Access Compliance Report

Public Rights-of-Way

Intersection ID: 49223	Main Street: ERIN_TAYLOR_LN	Cross Street: ANNA_GARRISON_RD	Location: S
ADA ID: 5EBDDD3D1AD1	Ramp Type: PerpDiag	Initial Pass/Fail: Fail	Overall Compliance: No
Severity Score: 35			
Codes/Mitigation Info/Possible Solution		Field Measurements/Component Compliance

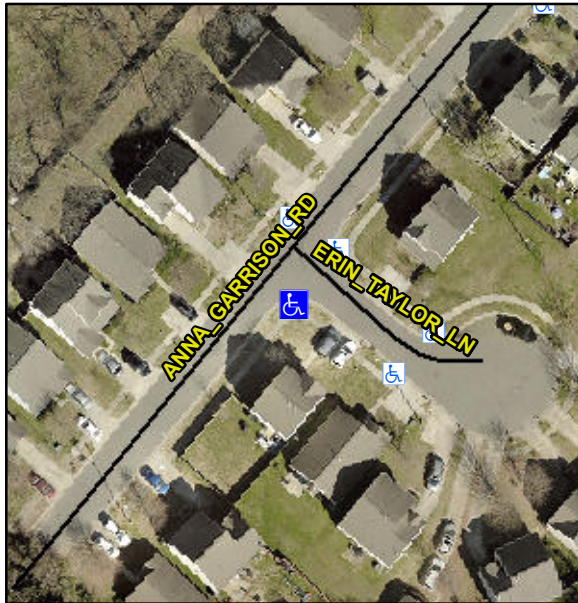
PROW/ADA:

Not Found, R304.5.1

Remove & Replace Curb Ramp With Two New Directional Ramps or Equivalent.
